**Subject: Response to Portion of NRC Request for Additional Information Letter No. 110 Related to ESBWR Design Certification Application - Containment Systems - RAI Number 6.2-140 S01**

**Response to Portion of NRC Request for  
Additional Information Letter No. 110  
Related to ESBWR Design Certification Application**

**RAI Number 6.2-140 S01**

Figure 6.2-140S01-1: Containment Pressure Response, 0-10 Days

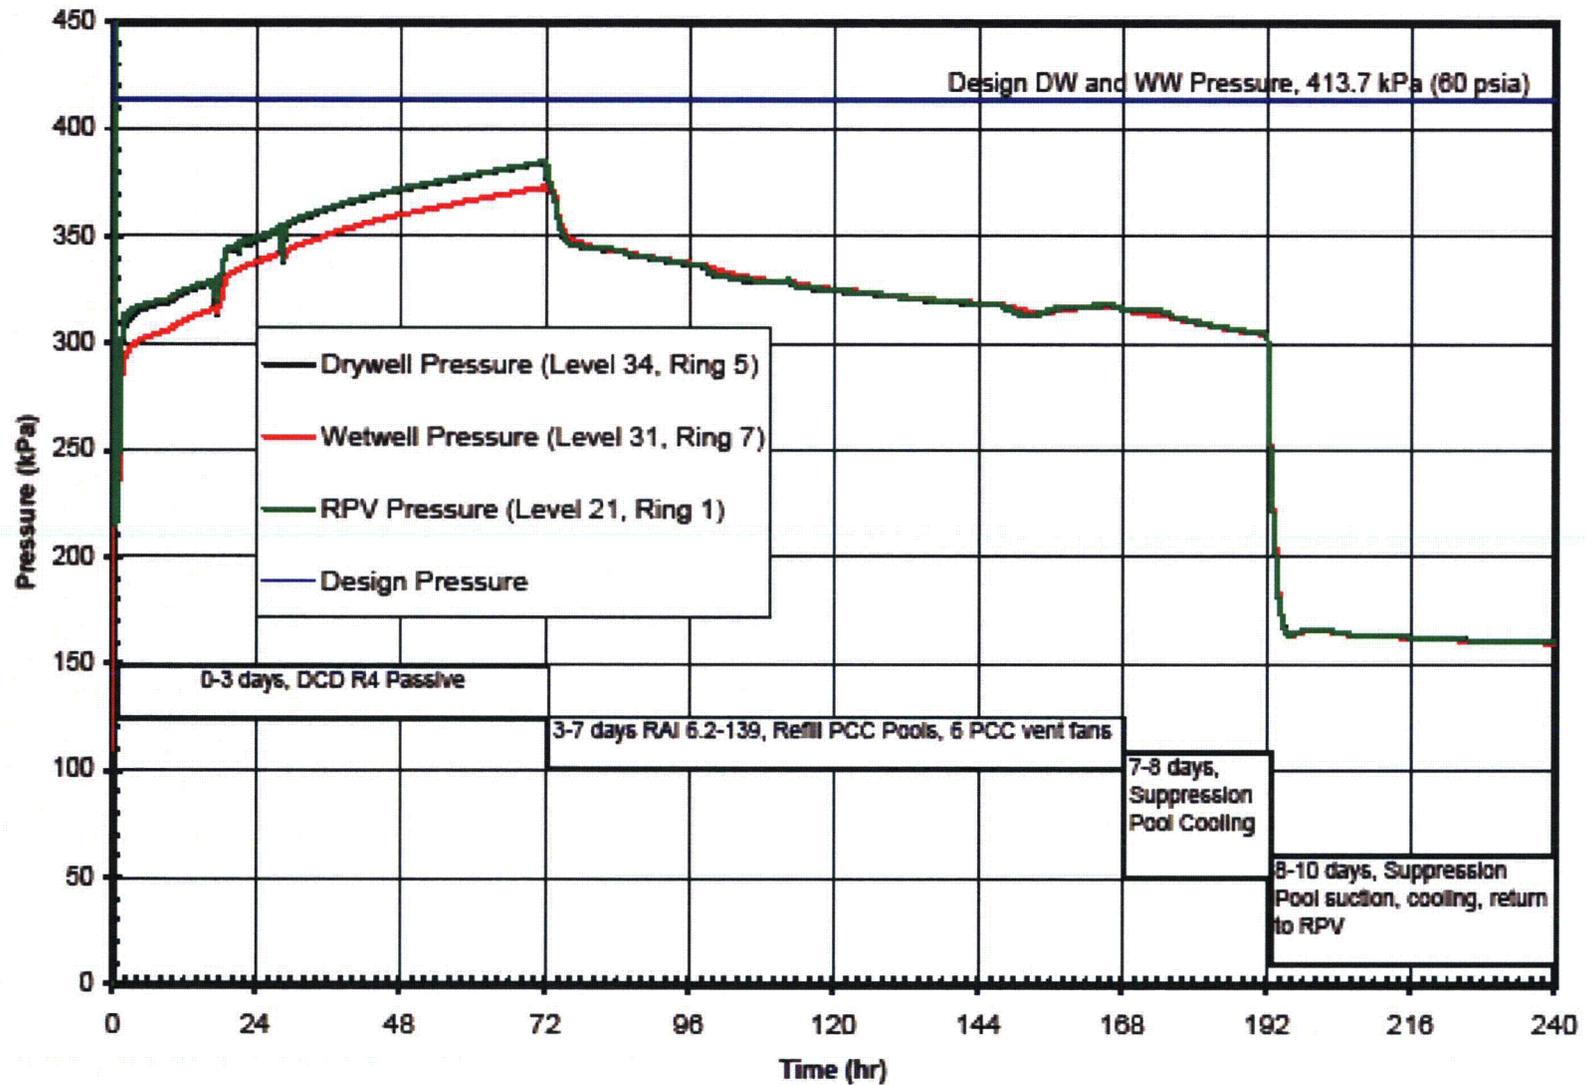
*In response to RAI 6.2-140, GEH provided results of containment pressure following a loss of coolant accident that were predicted using TRACG analysis extending up to 7 days. The containment pressure predicted was below the design value for 7 days under the assumptions that the isolation condenser (IC)/passive containment cooling (PCC) pool refill occurred at 3 days and the radiolytic gas production ceased after 3 days. However, the containment pressure appeared to be continuing to rise and could exceed design pressure after 7 days. Further, staff confirmatory analyses also show containment pressure continues to rise and could exceed design pressure before 7 days depending on the bypass leakage that is assumed.*

*Describe how the ESBWR design meets General Design Criterion 50. Show that resulting containment pressure and temperature following a LOCA can be mitigated sufficiently to reduce and control pressure for the long term. In addition, discuss appropriate treatment of all non-safety systems credited to provide this function after 72 hours, consistent with SECY 94-084.*

The ESBWR containment is designed to accommodate, without exceeding the design leakage rate with sufficient margin, the calculated pressure and temperature conditions resulting from any loss-of-coolant accident (LOCA), as required by 10 CFR 50 Appendix A, General Design Criterion (GDC) 50. GDC 50 is met by the ESBWR containment structure, which is designed to accommodate the pressure and temperature of loss-of-coolant accident (LOCA) conditions as calculated and described in DCD Tier 2, Section 6.2. The containment pressure and temperature responses are shown in the attached Figure 6.2-140 S01-1 and Figure 6.2-140 S01-2.

Containment pressure and temperature responses using an example accident recovery evolution using the RWCU/SDC crosstie option are shown in the attached Figure 6.2-140 S01-1 and Figure 6.2-140 S01-2. These response curves credit the RWCU/SDC non-regenerative heat exchanger (NRHX) operating in suppression pool cooling mode for 24 hours beginning at 7 days following a LOCA, followed by vessel injection via the SDC system with suction from the suppression pool. This TRACG calculation starts with decay heat and other containment conditions at 7 days. However, there is no requirement to start these accident recovery options at 7 days since the reactor is in a safe stable shutdown condition, and containment pressure and temperature continue to be maintained with sufficient margin to containment design limits for a sufficient time period to allow for use of other non-safety related, non-RTNSS SSCs to be placed in service to achieve cold shutdown.

The analysis shows that after being in suppression pool cooling for 24 hours, and then injecting into the reactor vessel for approximately 10 hours, the suppression pool temperature reaches equilibrium with the reactor bulk water temperature at 70°C (158°F). Therefore, with the suppression pool temperature being less than 93.3°C (200°F) and in equilibrium with reactor bulk water temperature, the average reactor coolant temperature is less than 93.3°C (200°F) and the reactor is in cold shutdown, which is considered the end of the accident recovery phase. Table 6.2-140 S01-1 lists the RWCU/SDC NRHX data used in the analysis.
